| Product Change Notification | | | | | PCN MGA series change of blister belt | | |
| owner | creation date | release date | released by | change order no | rev | page | D10-042-010 |
| elmigeth | 08.01.2021 | 08.01.2021 | haeckima | 2018992 | B | 1 of 2 | |

| Old product description | New product description |
|---|--|
| Old product picture | New product picture |

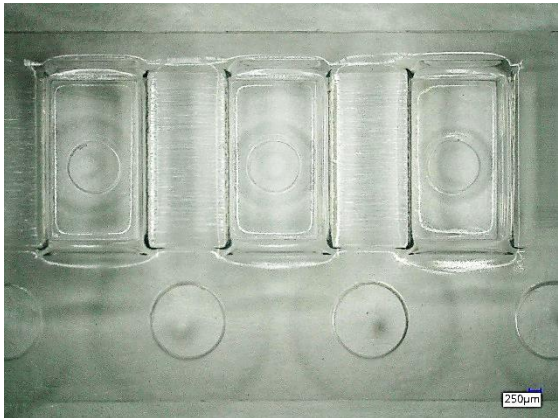
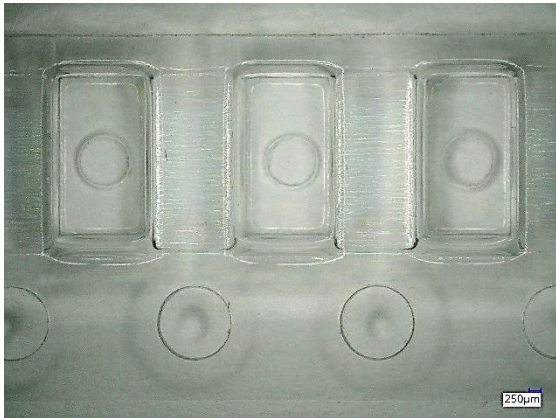
Change of material

| Old product description | New product description |
|---|--|
| H-PVC transparent, shiny, antistatic | PET GAG, volume antistatic, transparent |
